PROPOSED CLAY TARGET ASSOCIATION CLUB HOUSE & FUNCTION CENTRE FACILITY
72 TASMAN ROAD, WAGGA WAGGA

SITE / SITE ANALYSIS PLAN

A00SP

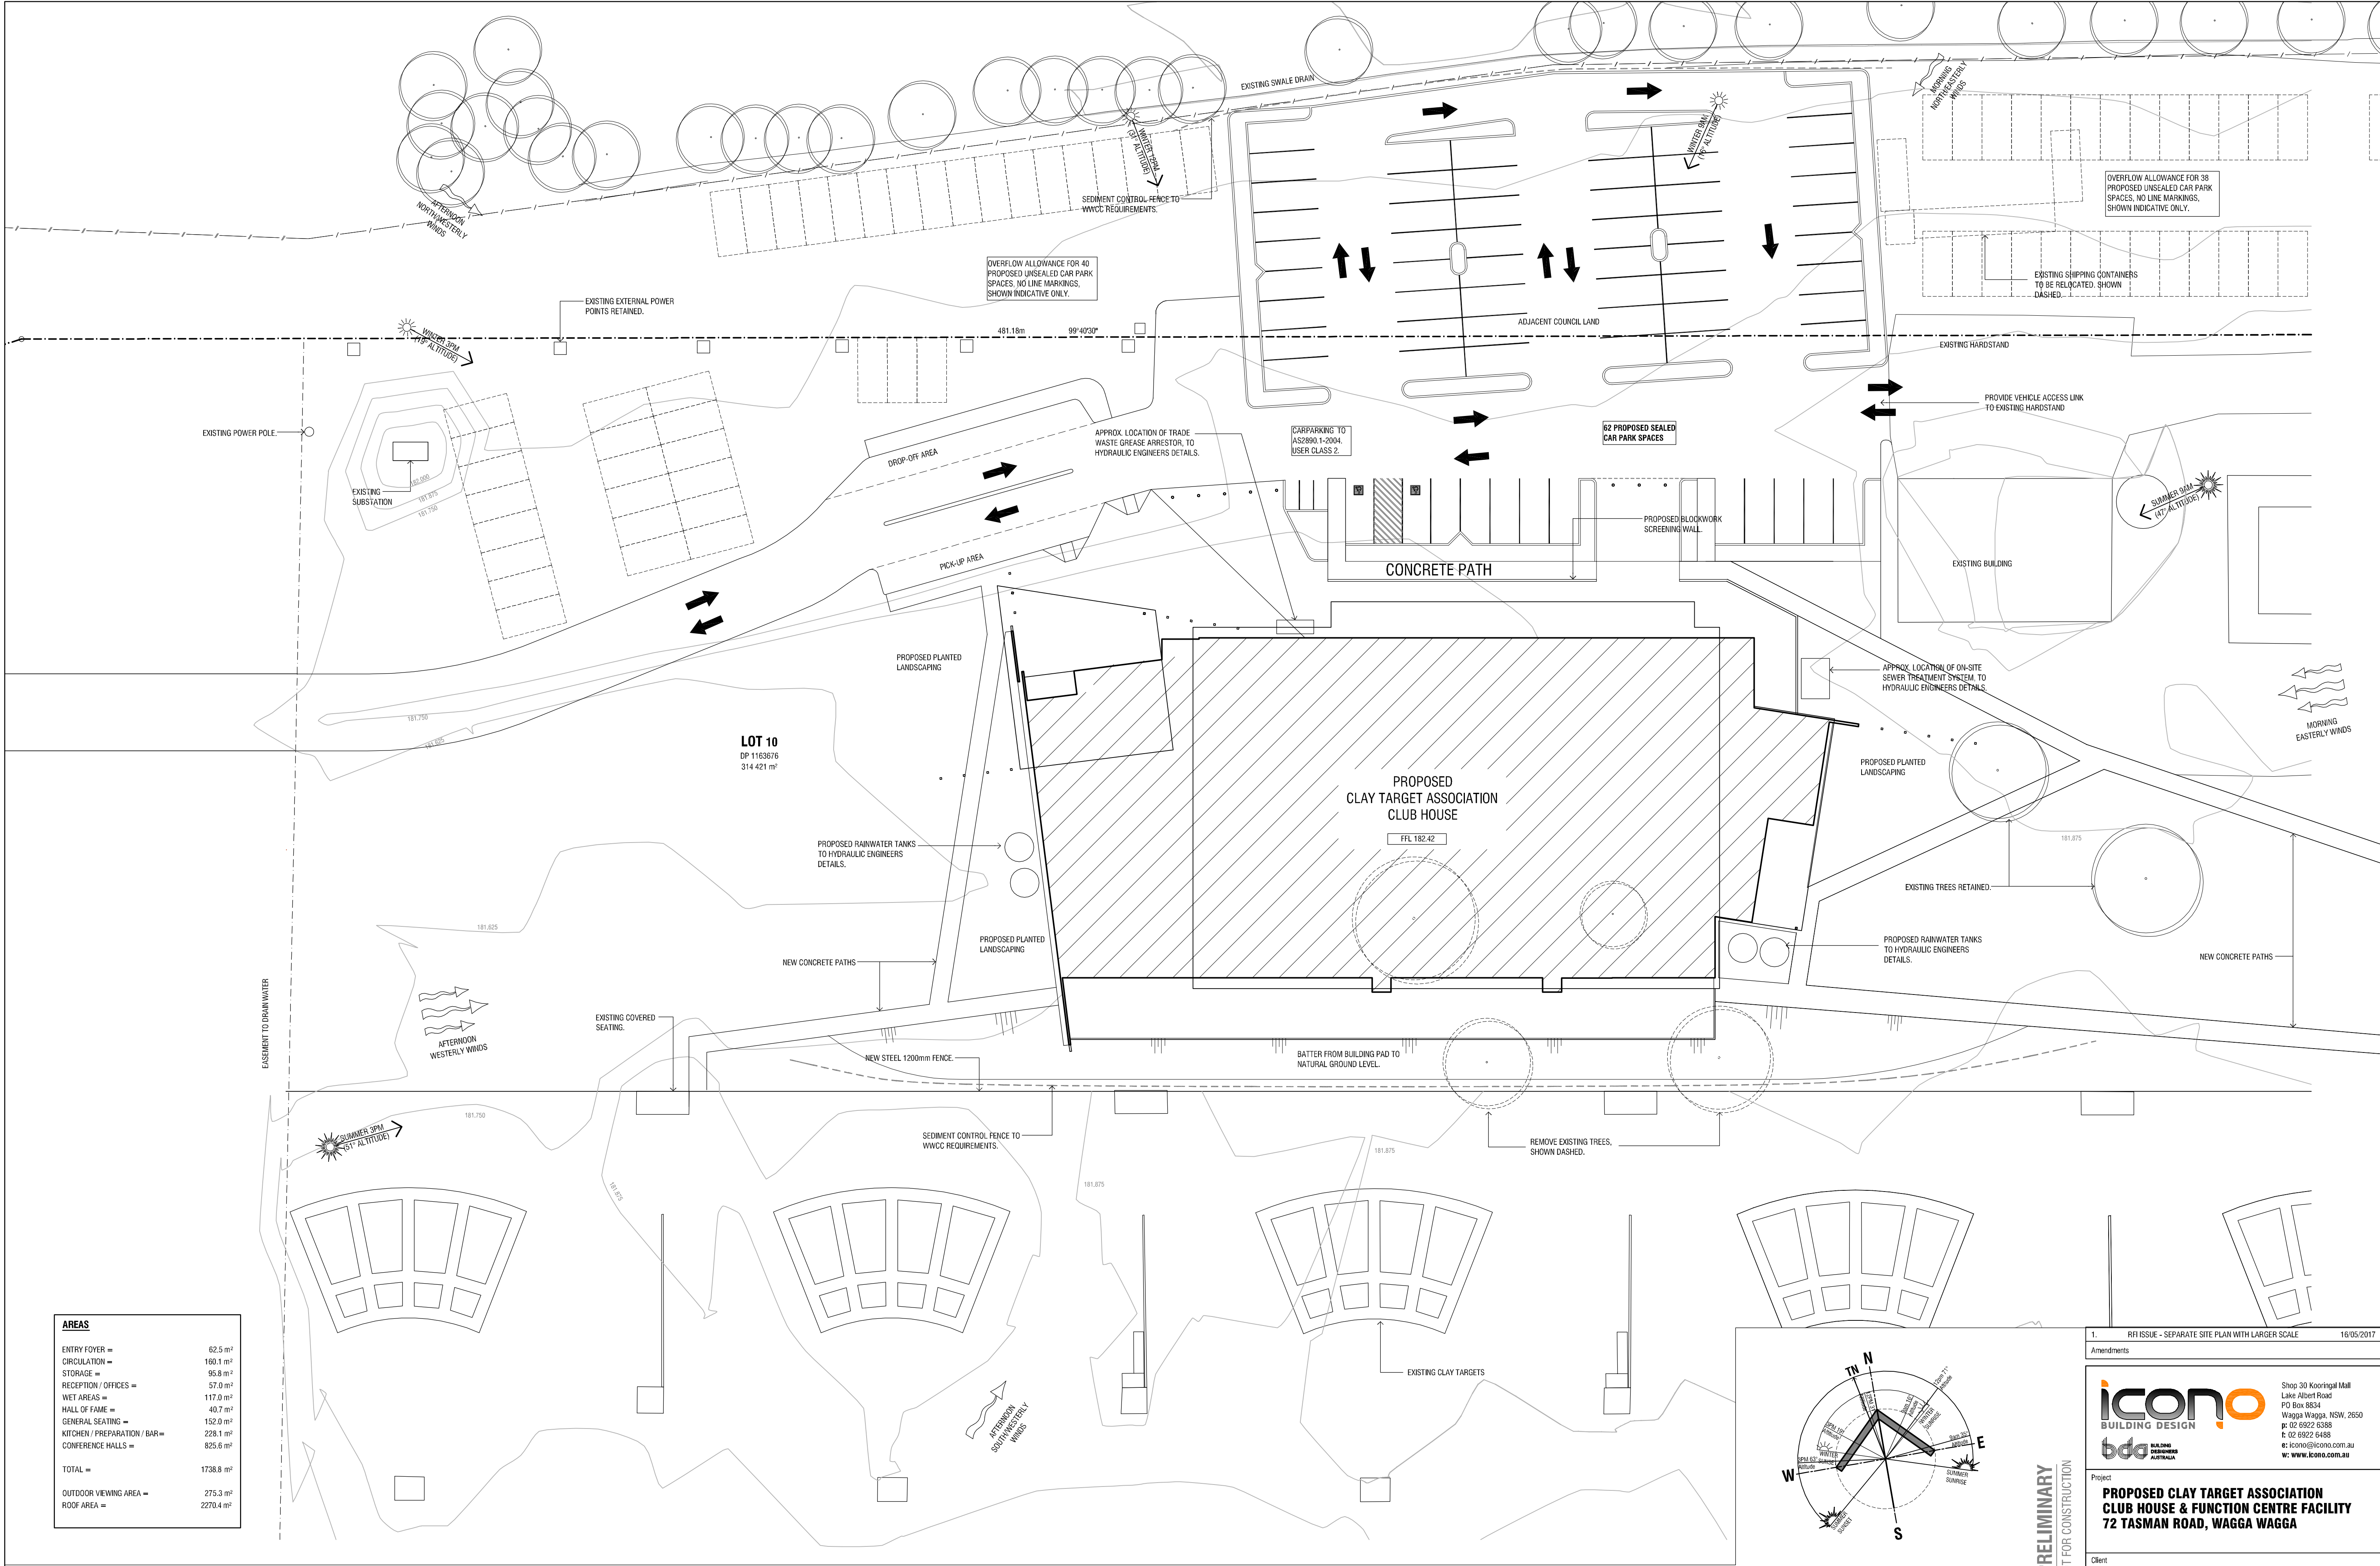
1. RFI ISSUE - SEPARATE SITE PLAN WITH LARGER SCALE
